Palo Verde Nuclear  
Generating Station

**Subject: Palo Verde Nuclear Generating Station (PVNGS)  
Units 1, 2, and 3  
Docket Nos. STN 50-528, 50-529 and 50-530  
Response to Request for Additional Information – Relief Request 38**

**Response to Request for Additional Information – Relief Request 38**

WELD 5-10  
SPRAY NOZZLE

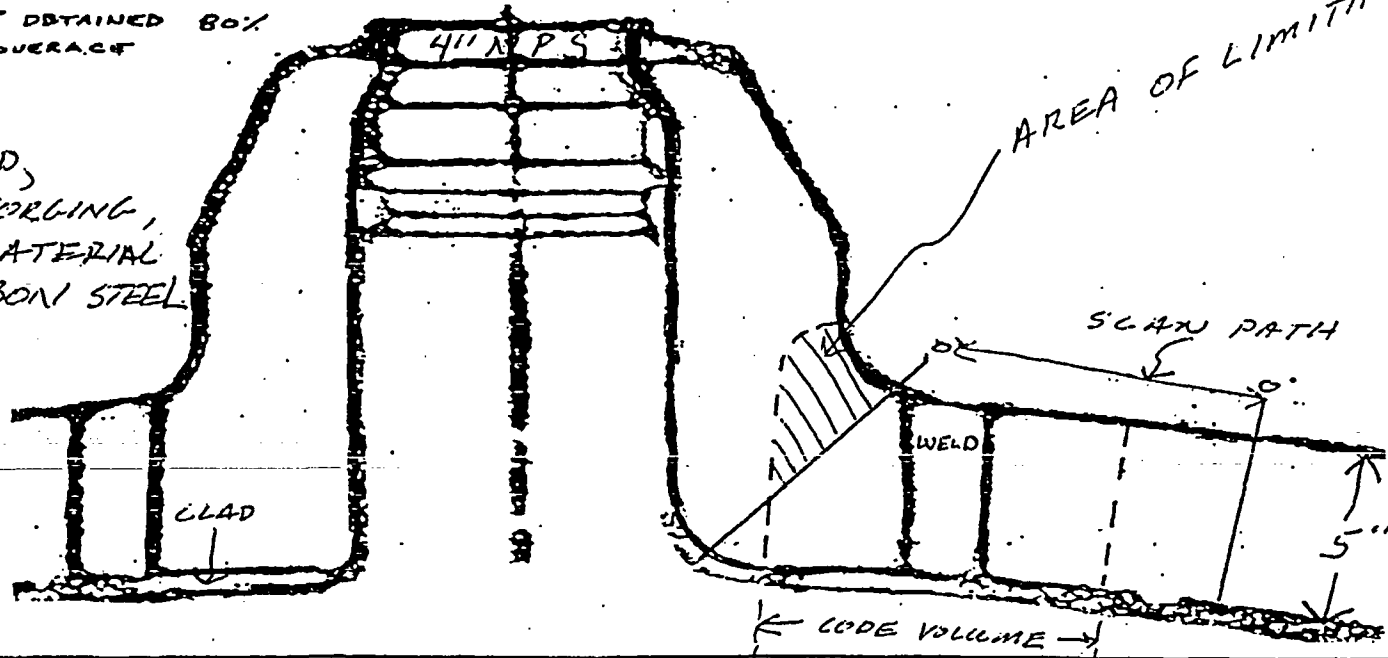
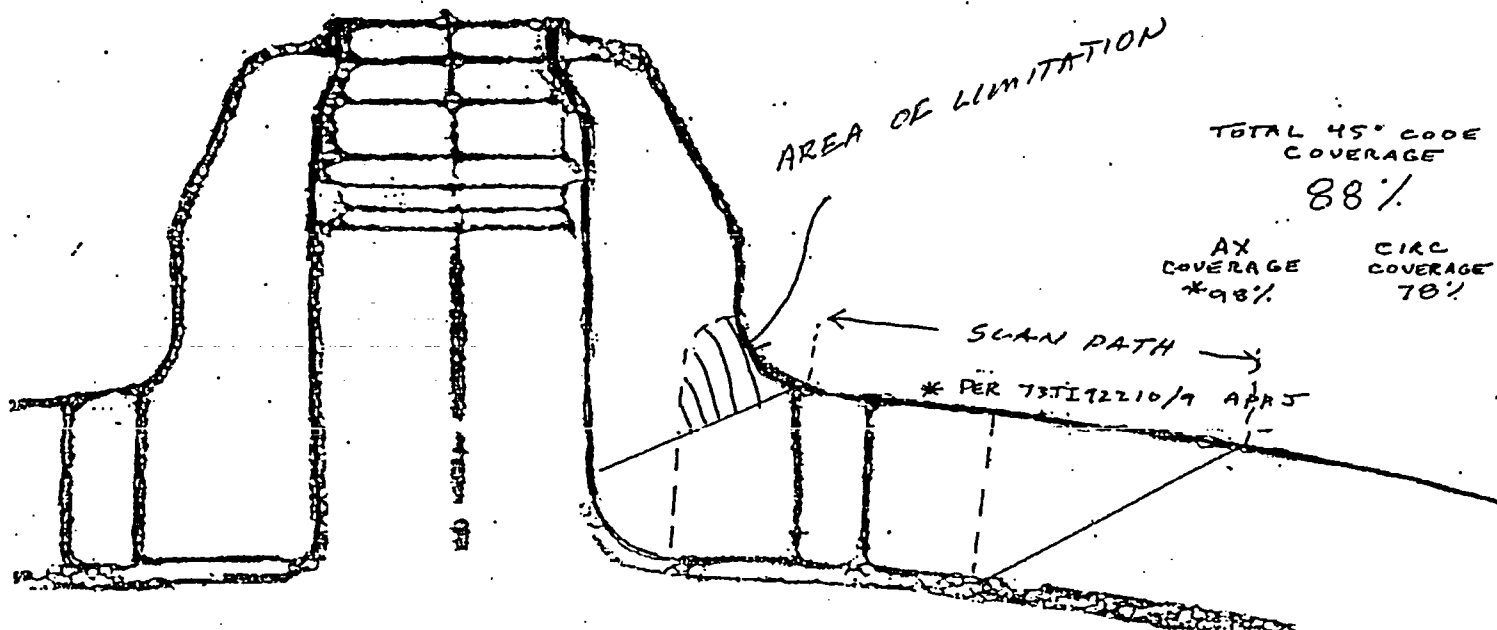
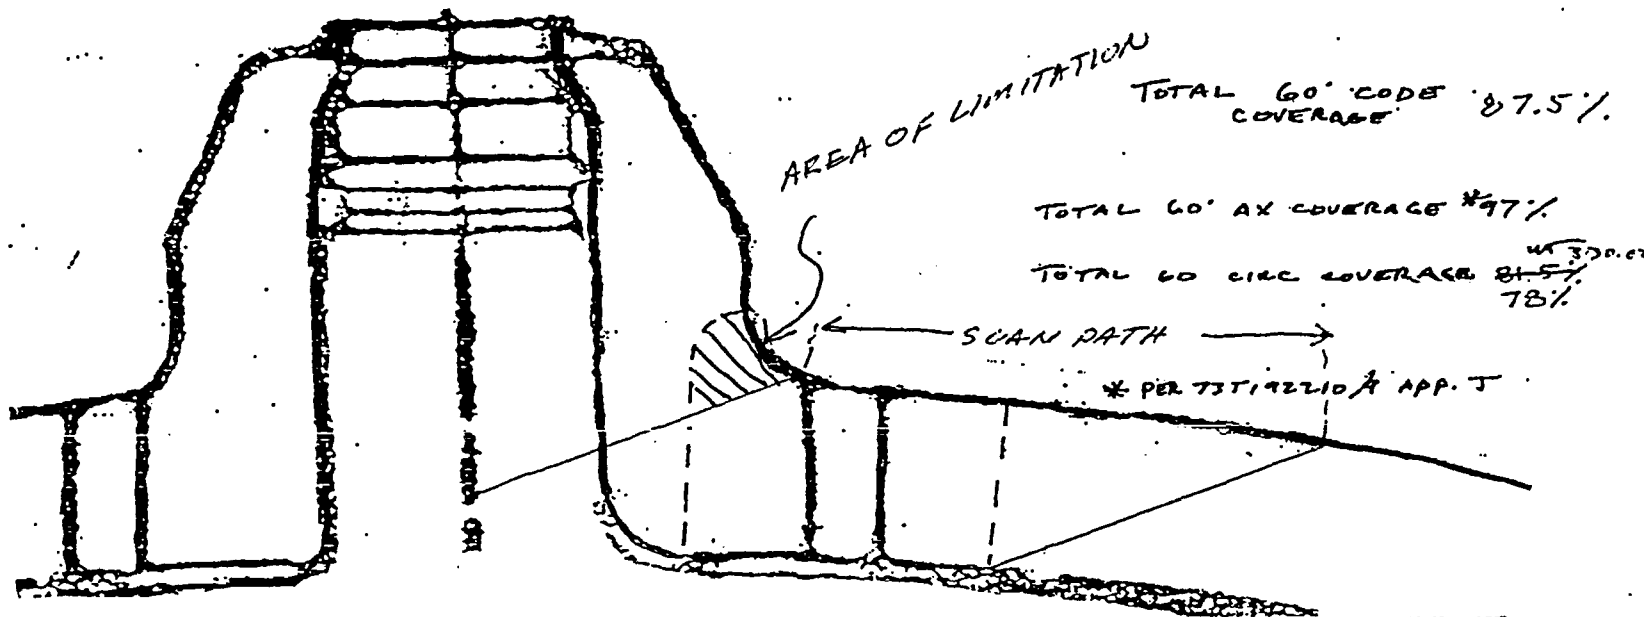
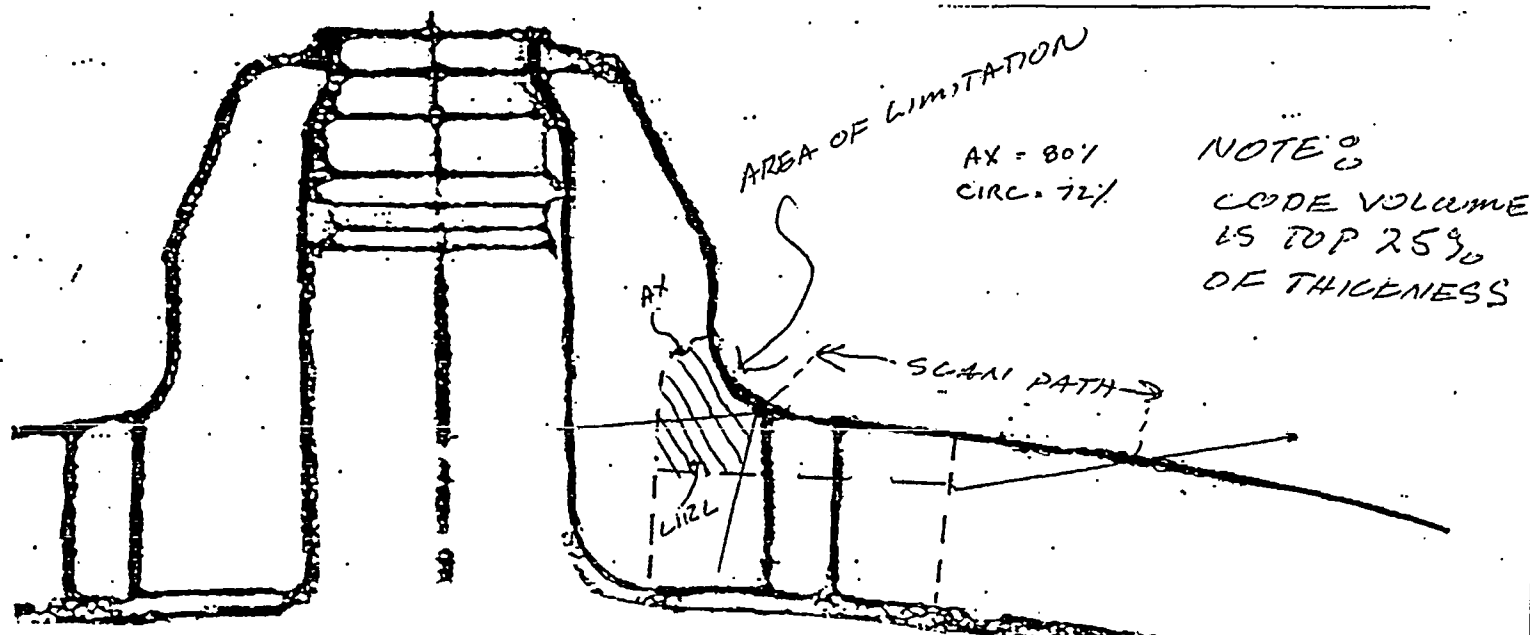
Provide detailed information to support the basis for the limited examinations of pressurizer nozzle-to-vessel welds 5-10, 5-13, and the basis for demonstrating impracticality. Include detailed descriptions (with sufficient explanation, and lay-out or cross-sectional drawings/sketches) to enable the staff to understand the causes of ultrasonic scan limitations and their impact on examination volume coverage.

The cross sectional sketches of welds 5-10 and 5-13 are included in Attachment A. These sketches show the weld configuration, material thickness, scan path limits, and ultrasound beam path. These sketches show that the area of code volume not examined is the portion of the upper volume of the nozzle forging material. In both cases, 100% of the weld filler material was examined.

Comments: 0° OBTAINED 80%  
COVERAGE

Drawing for Question 2.3(a)

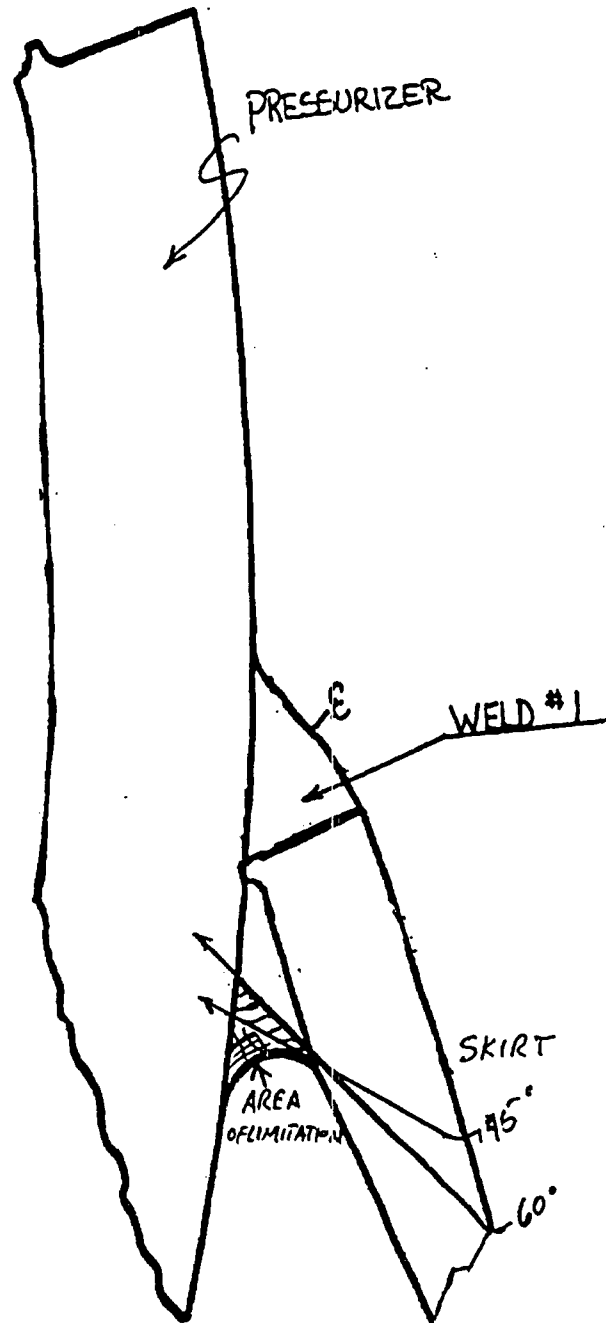
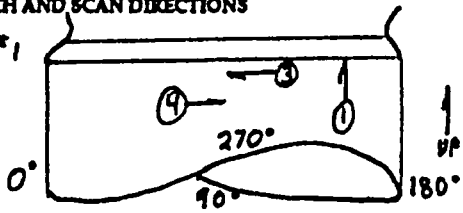
Provide a cross-sectional sketch showing the pressurizer support skirt weld. Include in this sketch a depiction of how the volumetric technique was applied and coverage obtained.

Attachment B contains the cross sectional drawing of the pressurizer support skirt weld that was taken from Unit 2 ultrasonic examination report number UT-06-088. The drawing depicts the weld configuration and the portion of the attachment weld that could not be examined. The 45 and 60-degree arrows represent the transducer exit point and sound propagation path.

Sketches for Question 2.4(b) and 2.6(b).

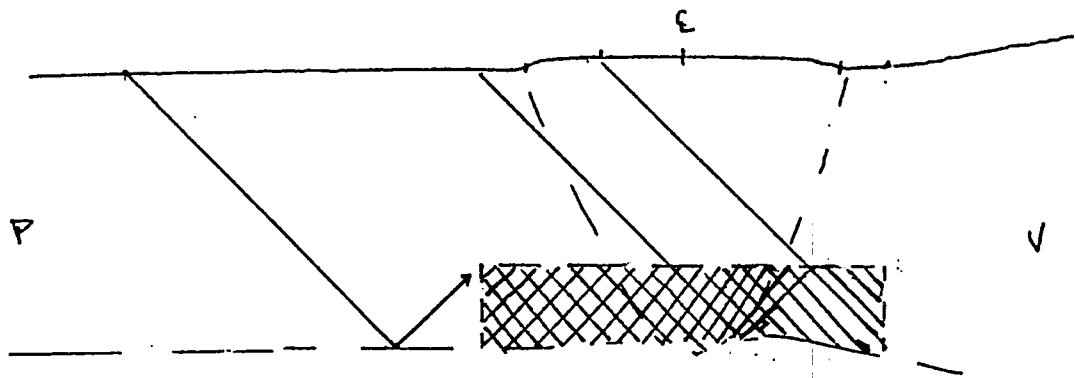
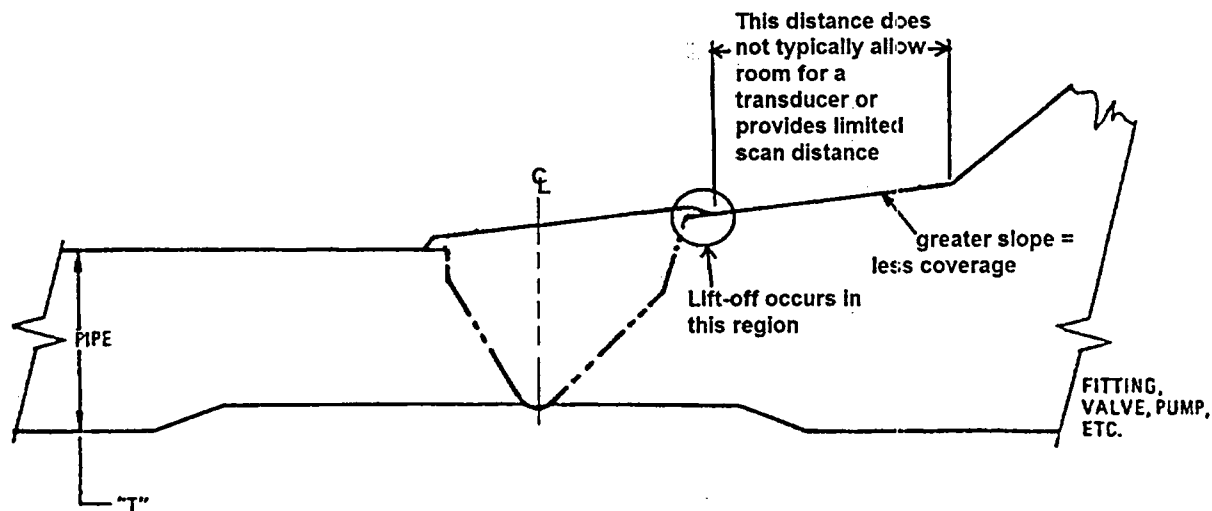
Provide detailed information to support the basis for each limited ASME Code, Section XI, Examination Category B-J weld and, therefore, demonstrate impracticality. Include detailed descriptions (with sufficient explanation, and layout or cross-sectional drawings/sketches) to enable the staff to understand the causes of ultrasonic scan limitations and their impact on examination volume coverage.

Provide detailed information to support the basis for each limited ASME Code, Section XI, Examination Category C-F-1 weld and, therefore, demonstrate impracticality. Include detailed descriptions (with sufficient explanation, and layout or cross-sectional drawings/sketches) to enable the staff to understand the causes of ultrasonic scan limitations and their impact on examination volume coverage.

All of the B-J piping welds were examined in accordance with the Performance Demonstration Initiative (PDI) generic procedure PDI-UT-2. No limitations to the procedural requirements were encountered. Attachment C contains a sketch of a typical weld profile (pipe-to-fitting, pipe-to-valve, pipe-to-pump, etc.) configuration. As shown in the sketch, these types of welds contain a taper as the connection transitions into the attached item. As a result of the slope of this taper and limited distance from the weld to the attached item, no meaningful axial scans can be performed from the tapered side of the weld as shown in Attachment C. The coverage plots from two B-J welds 22-11 and 23-4 are included to show the field application.

requirements were encountered. Attachment C contains a sketch of a typical weld profile (pipe-to-fitting, pipe-to-valve, pipe-to-pump, etc.) configuration. As shown in the sketch, these types of welds contain a taper as the connection transitions into the attached item. As a result of the slope of this taper and limited distance from the weld to the attached item, no meaningful axial scans can be performed from the tapered side of the weld as shown in Attachment C. The coverage plots from two C-F-1 welds 77-14 and 85-46 are included to show the field application.

Drawing and Photos for Question 2.5(b)

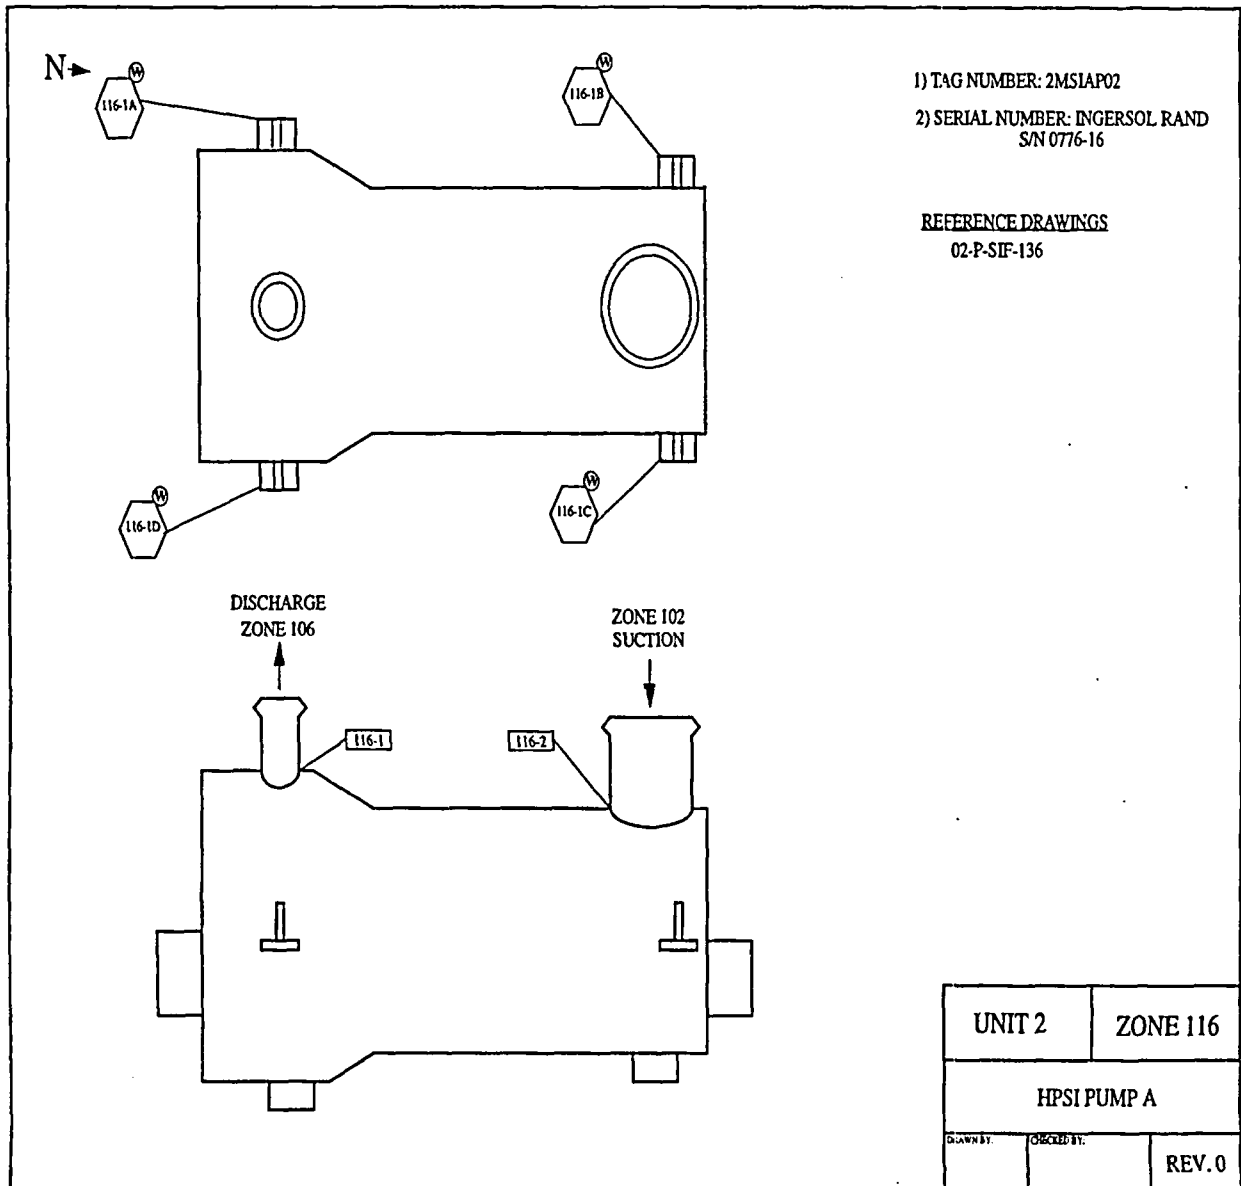
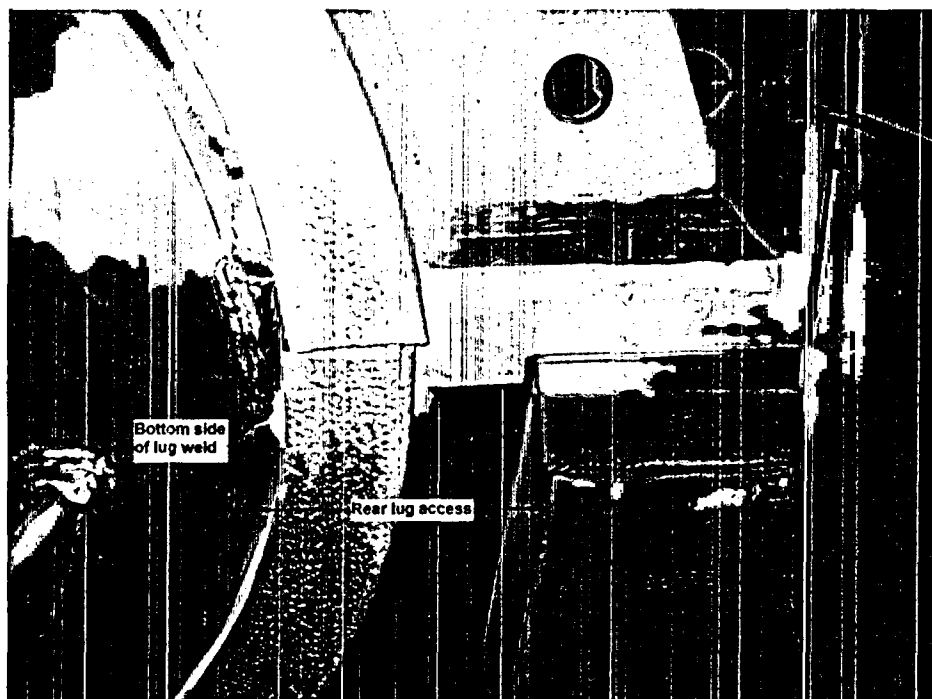
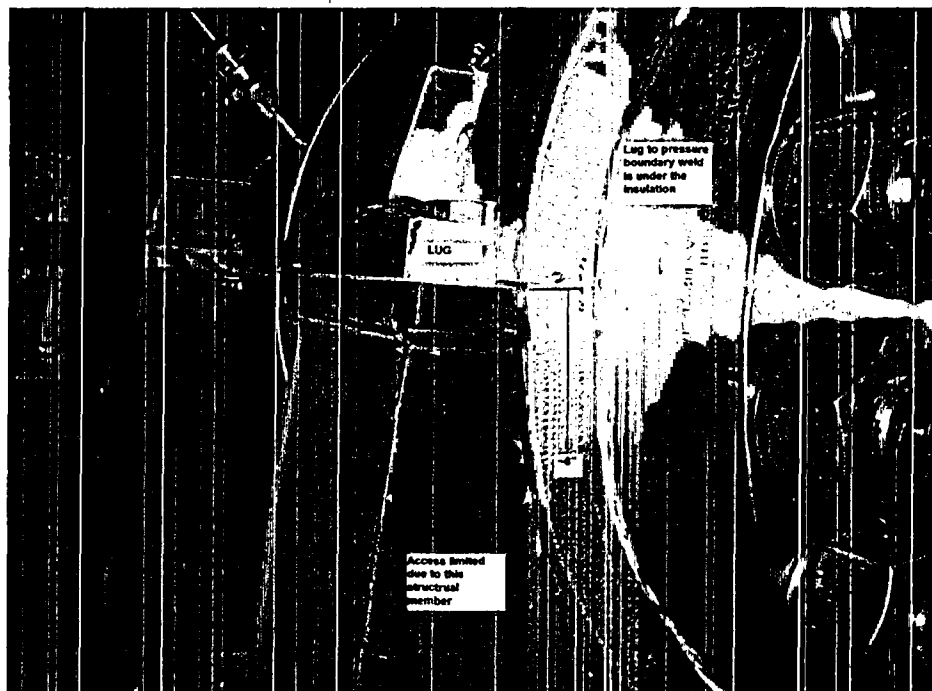
Provide a sketch or photograph depicting the stated configuration of welded attachments on component supports 116-1B and 116-1C. Also, list the high-pressure safety injection pump designation for the subject supports.

The High Pressure Safety Injection pump has four integrally attached support lugs. The zone drawing shown in Attachment D lists the support designation for the subject supports. Two support lugs are on the front of the pump and two support lugs are on the rear of the pump. The limited lug-to-pump welds are the front lugs (weld numbers 116-1B and 116-1C). The rear lugs (116-1A and 116-1D) were not limited.

Also included are pictures of the front and rear support lugs. Access to the bottom side of the rear lug-to-pressure boundary welds (116-1A and 116-1D) is provided when the insulation is removed. No access to the bottom side of the front lug-to-pressure boundary welds (116-1B and 116-1C) is provided when the insulation is removed. Access to these welds (116-1B and 116-1C) is limited by the structural steel member that supports each lug as seen in the following pictures.

All four lugs were liquid penetrant examined to the maximum extent allowable. The rear lug welds (116-1A and 116-1D) were not limited and 100% coverage was obtained. The front lug welds (116-1B and 116-1C) were limited at the bottom side of the lug-to-pressure boundary weld. The examiner estimated the total coverage for all four lug welds to be 72%.

Based on the physical restrictions, APS considers the bottom surface of the front lug-to-pressure boundary weld to be impractical for examination.
